Office Action Summary

09/823,600

DETAILED ACTION

Attachment to Paper No. 18

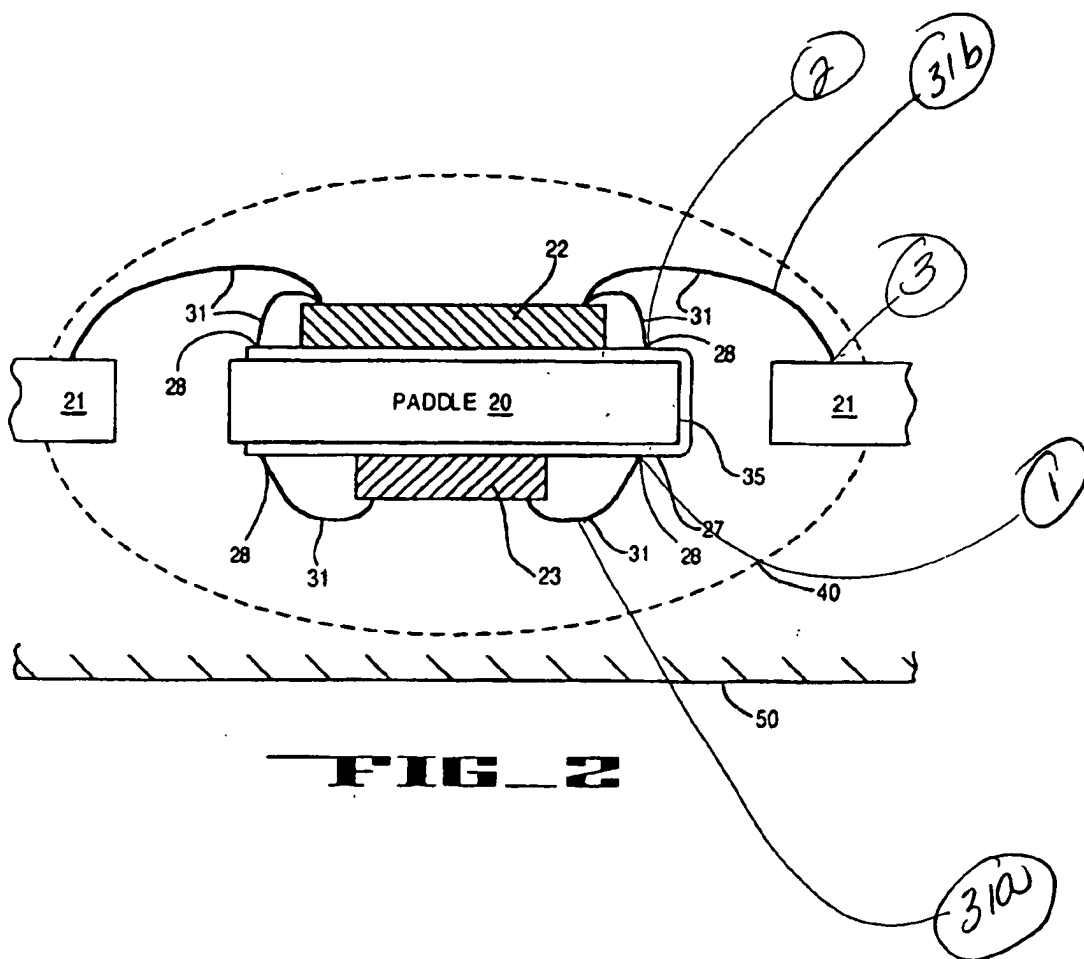
6. Regarding claim 18, Kuhn (see attached figure 2) shows a package having a substrate 20 for receiving a die down die 23 and/or a die up orientation 22. The die down die defines electrical contacts 1. The substrate comprises: a plurality of leads conductive traces (the wiring of the circuit 27) defining first contacts 1 which are arranged to accept connector wires making electrical connections from the electrical contacts of a die down die 23. Also, Kuhn shows second contacts 2 which are arranged to correspond to a die up die 22. The substrate can be placed into a package designed to accept a die up die (i.e. printed circuit board). The electrical connection may be made to the substrate second contacts as if it were a die up die (col. 1/lis. 14-27).

10. Regarding claim 45 Kuhn (see attached figure 2) shows a package having a substrate 20 and a lead 21 with contacts 3. Kuhn shows connectors wires 31b joining

the second contacts on the trace to the lead frame contacts. Also, the lead frame provides means to make electrical connection to a printed circuit board (col. 1/lls. 14-27).

18. Applicant argues that Kuhn does not describe the chips with respect to pad orientation, nor does consider pad orientation anywhere in this patent. This argument is not persuasive since Kuhn's figure 2 clearly shows a substrate that is capable to accept a die down die 23 as well as die up 22. Although the applicant uses terms different to those of Kuhn to label the claimed invention, this does not result in any structural difference between the claimed invention and the prior art. The use different terminology to describe the plurality of elements that constitute an integrated circuit, as this is just a writing style and the way in which a structural limitation is expressed does not affect the configuration of the described elements.

19. Applicant argues that Kuhn does not make connections from his contact 21 to chip 23. Nonetheless, Kuhn's figure 2 clearly shows that the chip 23 is electrically connected to the contacts via the traces 27 and the chip 22. Kuhn discloses that the lead frame 21 is used to externally connect the chips (i.e. 22, 23, col. 1/lis. 14-27). Moreover, this limitation is not recited in the rejected claim(s). Although the claims are

20. Applicant argues that Kuhn does not suggest a package designated to accept a specific die orientation where a die with different orientation can be mounted. Nevertheless, Kuhn discloses a substrate that is capable to receive a die up orientation or a die down orientation as evidenced by figure 2.
